Technical Review of the Draft Water Management Plan for the Chuitna Coal Project, Alaska

**Technical Review of the
Draft Water Management Plan
for the Chuitna Coal Project,
Alaska**

Figure 2. Monthly mean temperatures: Surface and groundwater.

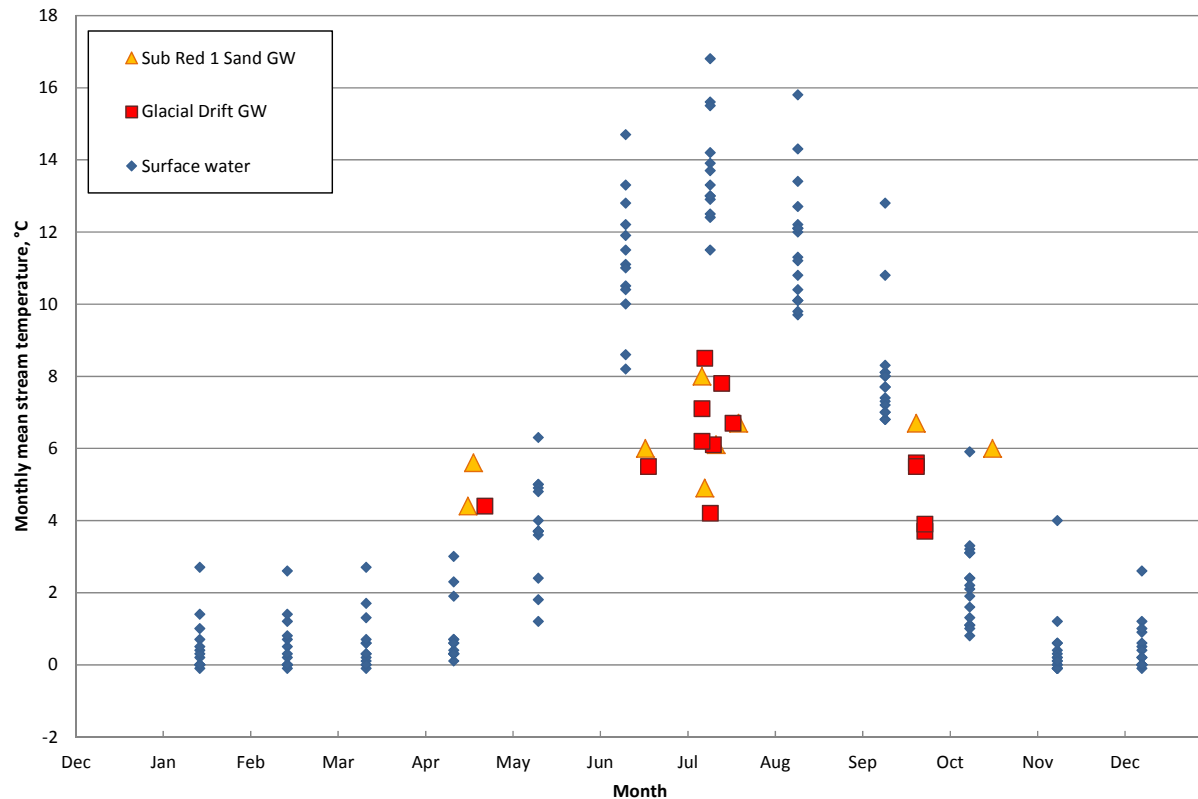
p. 27: “Temperature data for groundwater in the Glacial Drift and Sub Red 1 Sand hydrogeologic units are provided in Tables 5-7 and 5-8 (RTI, 2007)...Surface water control ponds will be continuously monitored for temperature during the months when they are discharging.”

According to baseline temperature data in the Hydrology Component Baseline Report (RTI, 2007), stream temperatures are 0–3°C from approximately November to April, and increase to 12–17°C in midsummer (Figure 2). In contrast, available data indicate that groundwater temperatures in both the Glacial Drift and Sub Red 1 Sand vary by only ~ 3–5° between April and July. Based on these data and the estimated pumping volumes from groundwater, it could be very difficult to maintain discharge temperatures that mimic the natural temperature variability present in these streams throughout the year, particularly in the stream reaches most immediately downstream from the discharge points. The plan should more explicitly calculate or model stream temperatures, and should also summarize the effects that changes in water temperature would have on aquatic biota if temperature criteria cannot be met.
